The Corporation of the
City of Sault Ste. Marie

Committee of Adjustment
July 22nd, 2026
2:00 P.M.
Council Chambers
Livestreamed/Zoom

AGENDA

PROP. GROUND FLOOR PLAN

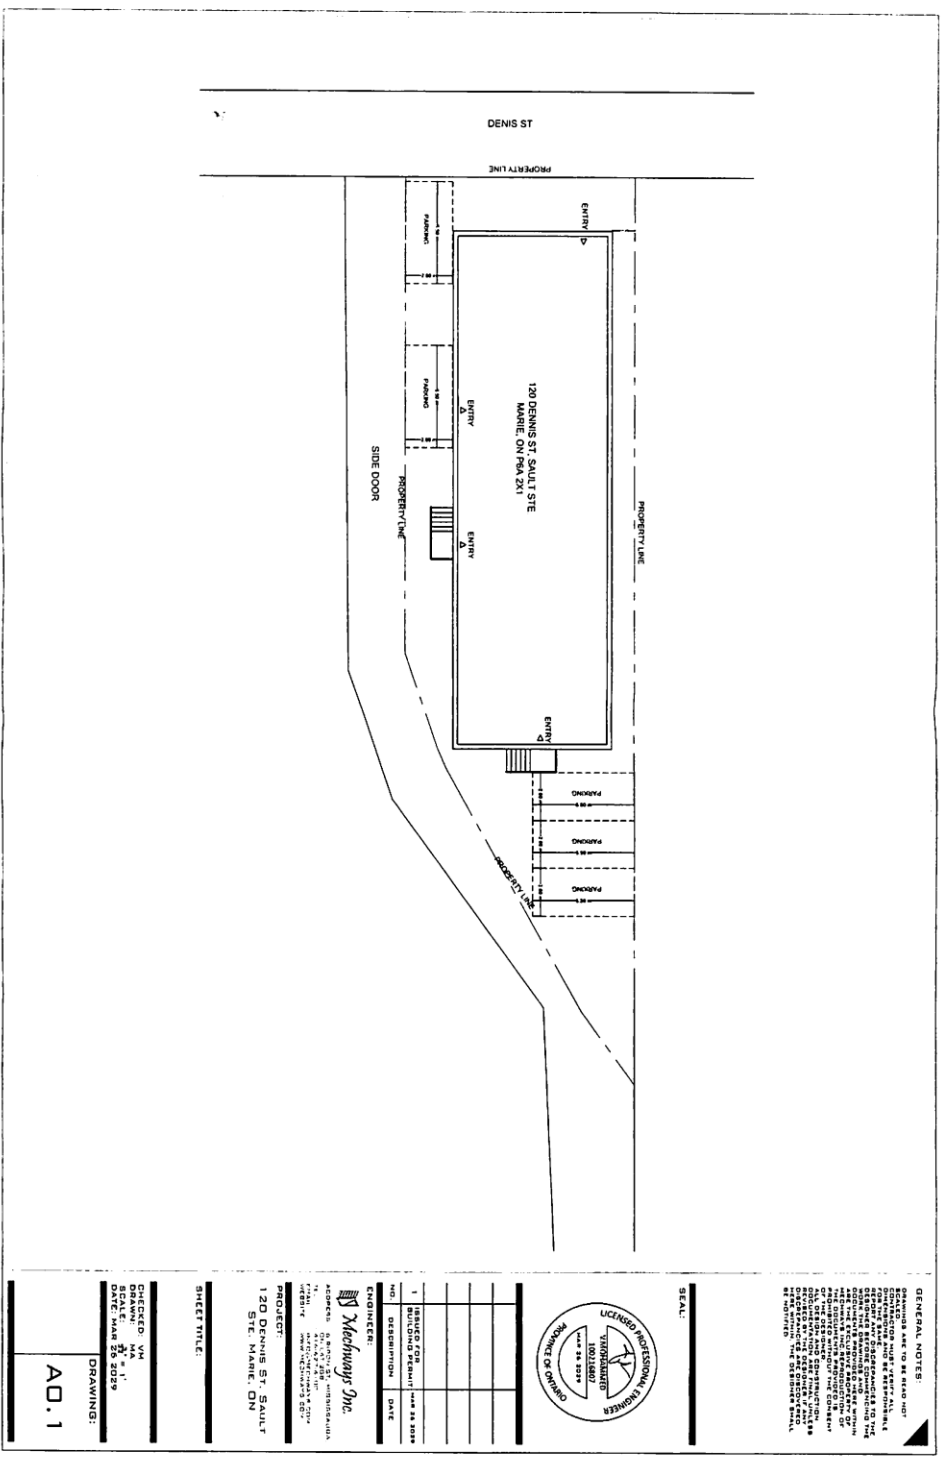
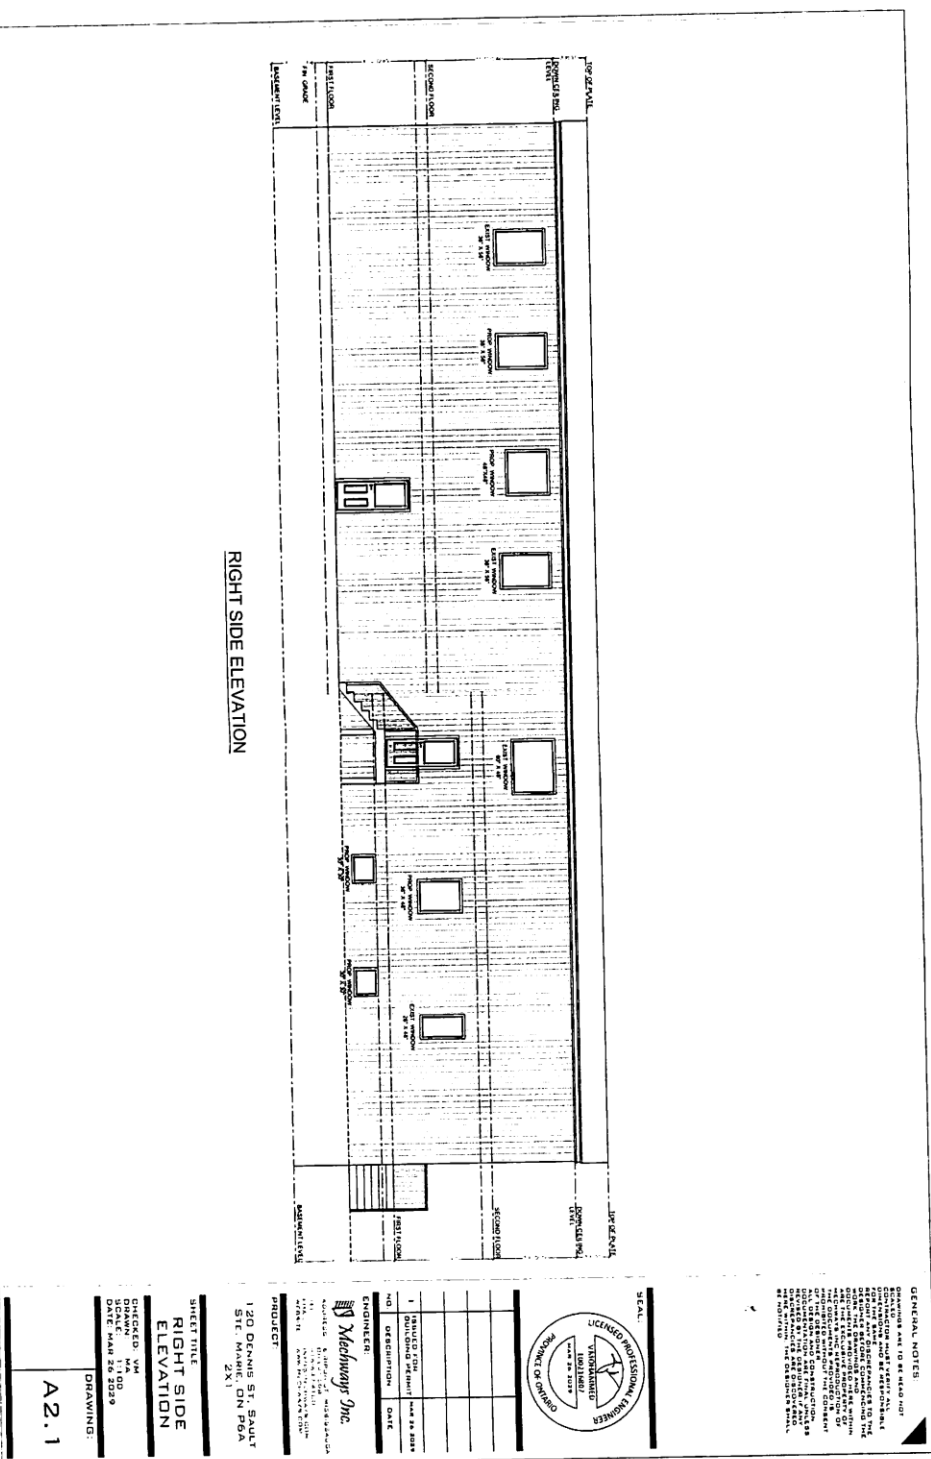
Building Division staff advised that provided there are no issues with the design and the permit is issued by plans examination, I don't have any objections to the residential units on the ground floor of the building.

Fire Services advised that all required approvals for the proposed residential use must be obtained through the Building Division. Upon completion of the approvals, the owner must prepare and submit a fire safety plan to Sault Ste. Marie Fire Services. The owner or their designate may contact our offices for details and assistance in completing the fire safety plan.

Public Utilities Commission (Water Utility) had no concerns with the minor variance. However, the Owner must engage the services of a Professional Engineer licensed in the Province of Ontario or persons qualified under the Ontario Building Code to verify if their existing water service is adequate to supply the necessary water demand for the proposed additional units. PUC must be provided with written confirmation from the Engineer confirming the outcome of their analysis. If the owner wishes to replace their water service, contact the PUC Engineering Department at 705-759-6576 to coordinate the water service requirements.

- a) A building permit must be obtained.**
- b) A fire safety plan must be approved by the Sault Ste. Marie Fire Services prior to the issuance of an occupancy permit.**
- c) The owner must engage the services of a Professional Engineer licensed in the Province of Ontario or persons qualified under the Ontario Building Code to verify if their existing water service is adequate to supply the necessary water demand for the proposed additional units. PUC must be provided with written confirmation from the Engineer confirming the outcome of their analysis prior to the issuance of a building permit.**

Foundation Plan
SCALE: 3/32"=1'-0"

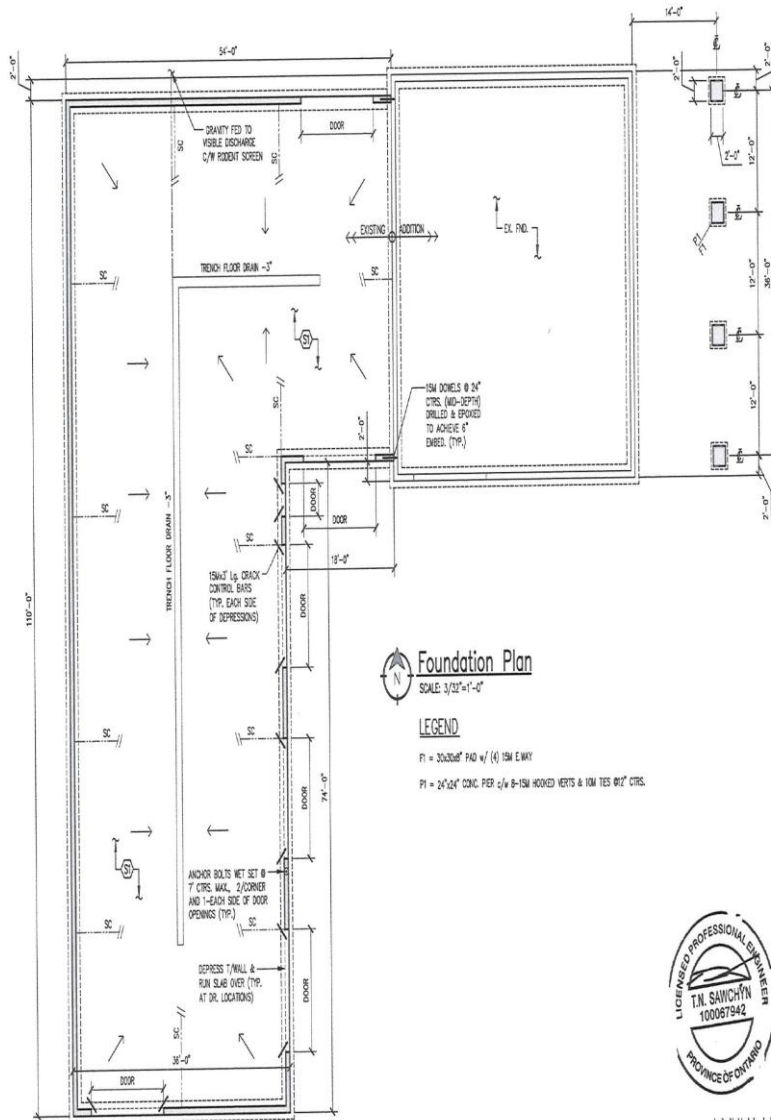
Building Division staff have no objection provided the proposed building is used for personal use only.

Based on the applicant's submitted plans, the existing garage roof will be replaced with an engineered truss roof, resulting in an overall height of approximately 8.7m. This is generally consistent with the height of the existing garage. Although relief is required for height, the proposal largely maintains the existing building height and primarily expands the garage horizontally. Most of the addition will be approximately 6.4m in height, which is closer to the R1 zone requirements.

- The owner must obtain a building permit for a main building on or before July 22, 2028.

PROJECT 1738 OLD GARDEN RIVER ROAD - GARAGE ADDITION
DRAWN BY EXTERIOR ELEVATIONS
DATE 10 MAY 2023
TAKEN 1748.00
REVISIONS 2023-23
SHEET A7

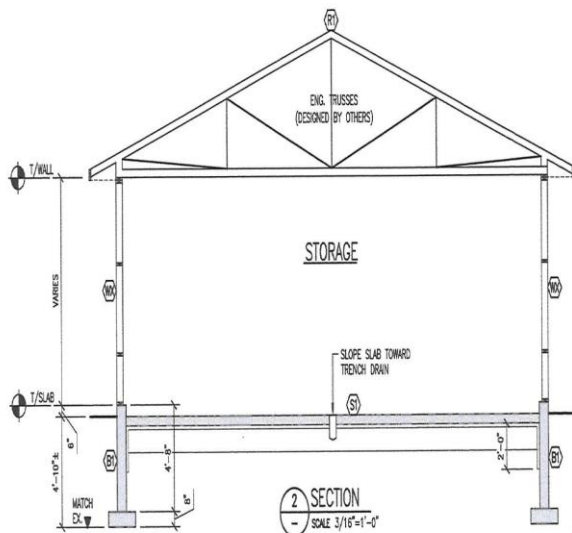
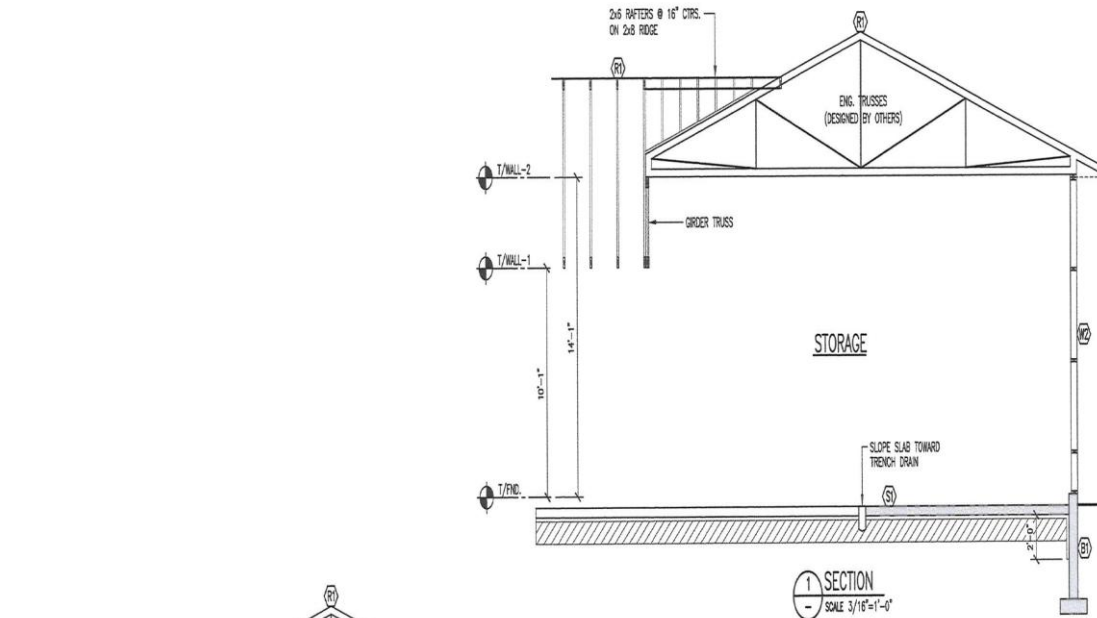
- The proposal generally maintains the garage's existing height while most of the addition will be lower in height than the current structure.
- Given the lot size and separation from nearby dwellings, the proposal is not expected to create adverse impacts related to overlook, shadowing, or privacy.
